HURRICANE CITY UTAH

Hurricane Planning Commission Meeting Agenda

November 9, 2023
6:00 PM

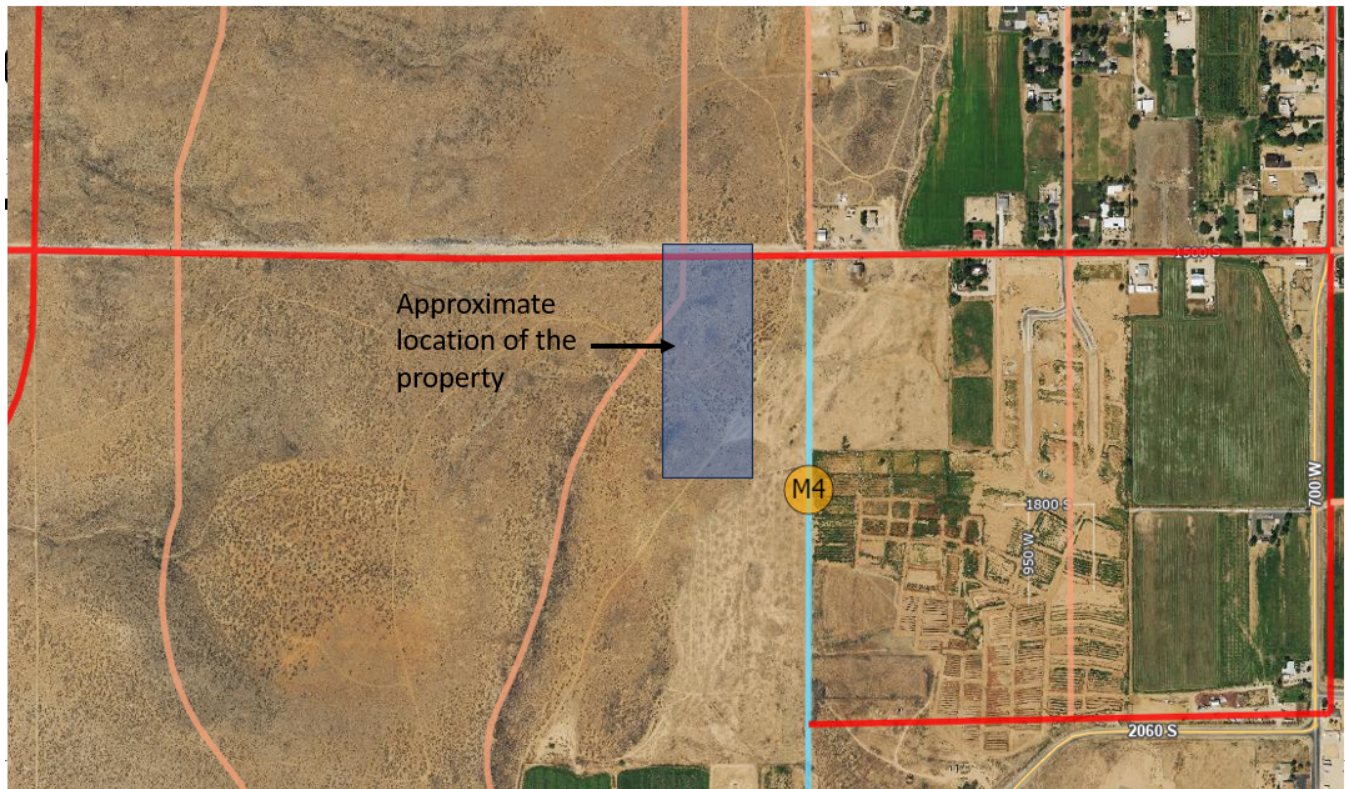
Public Works: This zone change should be denied. No utilities. No access.

Power: Power service ends east of the end of 1500 S. There is presently no capacity on the circuit to service the proposed additional units. However, in conjunction with the approved project to extend capacity on this area of the City, there may be a plan to bring power to the area. That developer could pay a proportionate share of the cost to achieve this capacity. The developer will be responsible for extending the distribution lines to the development, including acquisition of any needed easements. The approval of a zone change should be conditioned on a plan for power in the area and the ability to install distribution lines to the area.

Sewer: No exception to zone change. 8" main in 1500 S.

Engineering: Existing facilities are not adequate. Developments 30 units or greater require a primary and secondary access. The nearest paved portion of 1500 S is approximately 1500 feet from the subject property. The subject parcel is landlocked from a public street. The county recorder's office hasn't recognized right-of-way easements as explicit rights-of-way. Neighboring property owners will need to sign revised right of way documents and said documents will need to be recorded to connect the subject parcel to a public street. It appears the property is covered by two master planned roadways. It appears a

portion of the property is covered by a master planned detention basin. However, the nearest storm drain seems to be at the intersection of 920 W and 1500 S.

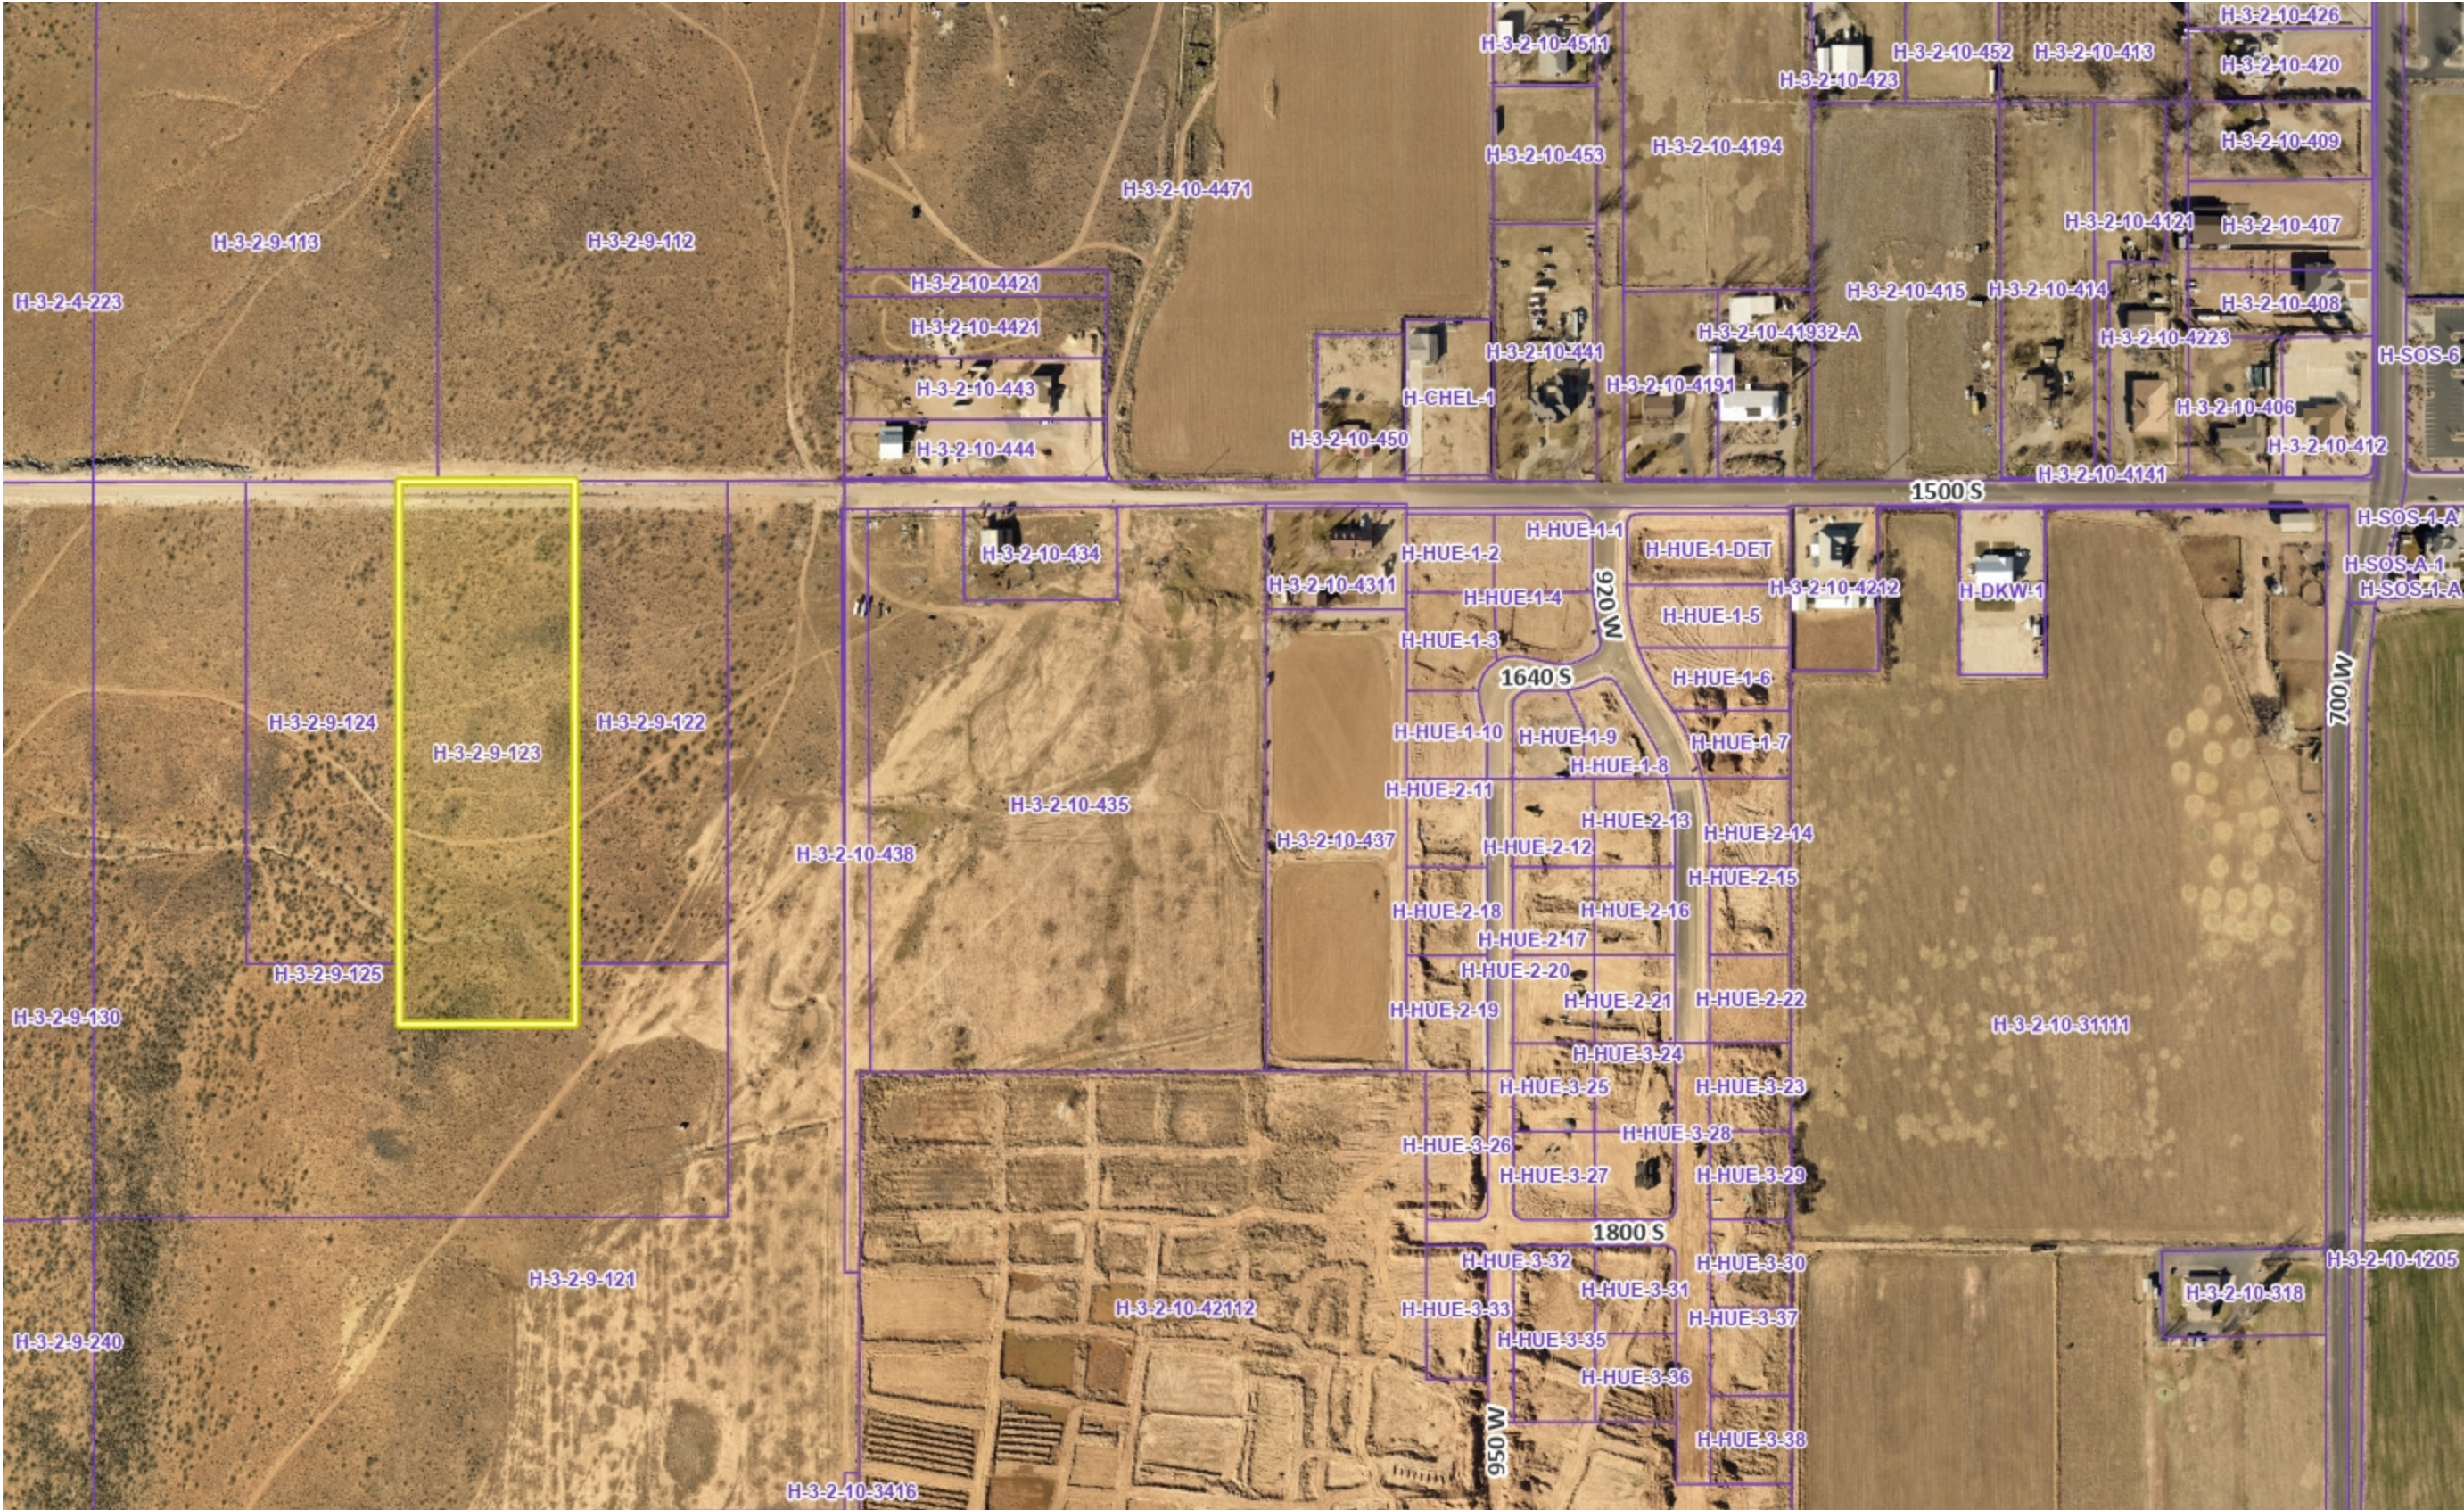
1. **Density:** The applicant has stated they want 53 units over 6.71 acres. This is compliant with RM-2 zoning which would allow up to 67 units. There are no available less-dense zoning options that would allow for what the applicant is requesting.
2. **Transportation Master Plan:** The 2019 Transportation Master Plan depicts this area in the picture below

- a. 1500 S is a planned 77' right of way of which there is currently a right of way easement for. The City is currently purchasing right of way for 1100/1150 W, however the roadway does not currently exist
- b. 1380 W is a planned 60' right of way that does not currently exist anywhere in the vicinity of the property.

Staff Comments

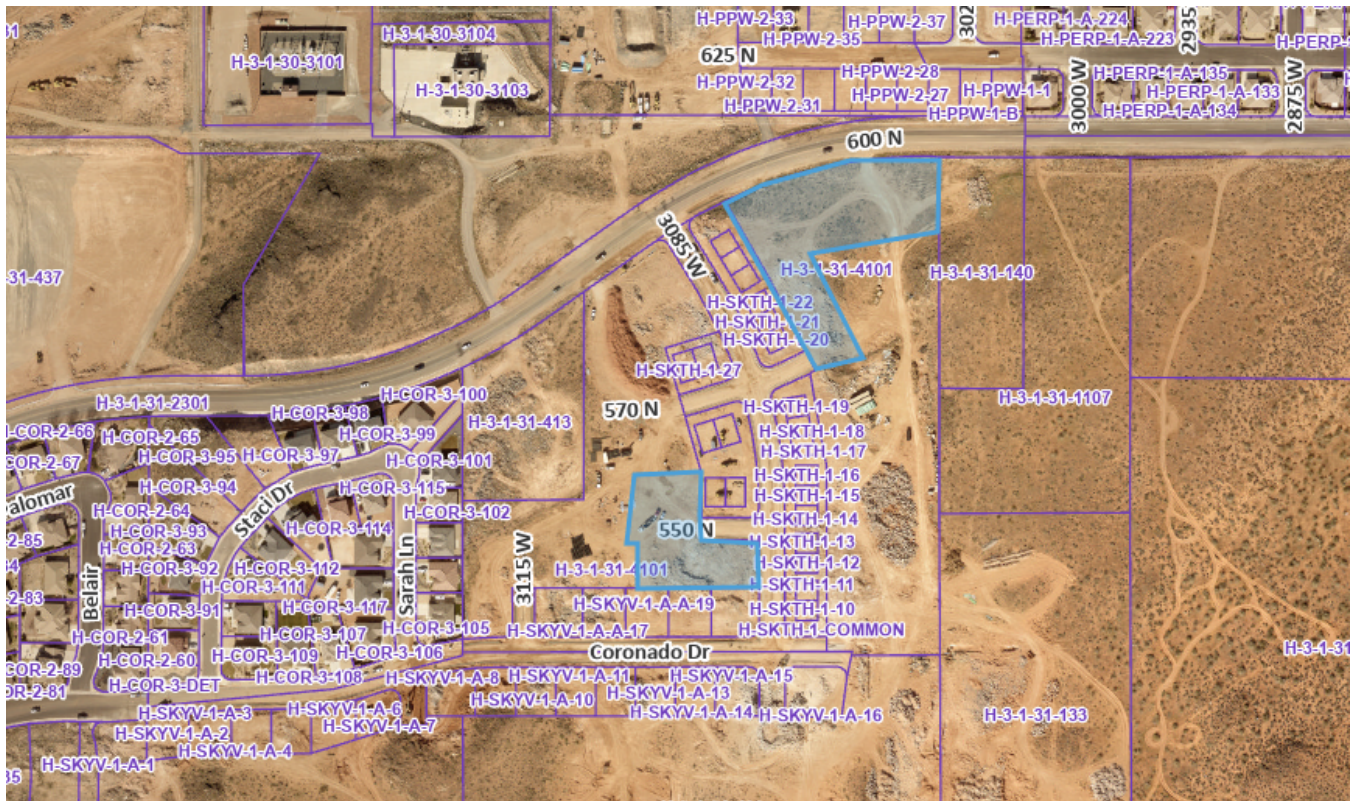
1. The application meets the requirements of the approved PDO and zoning.
2. The applicant has supplied a landscape plan that meets Hurricane City requirements of one tree and two shrubs for each unit.
3. The parks and open space are not located within this phase.
4. All street lights will meet current Hurricane City standards and outdoor lighting code.
5. The applicant has supplied a rendering of the townhomes. They are single-story buildings.
6. The applicant will need to provide two parking spaces for each unit. The units are proposed to have two-car garages with driveways that are 22' long that meet these standards.
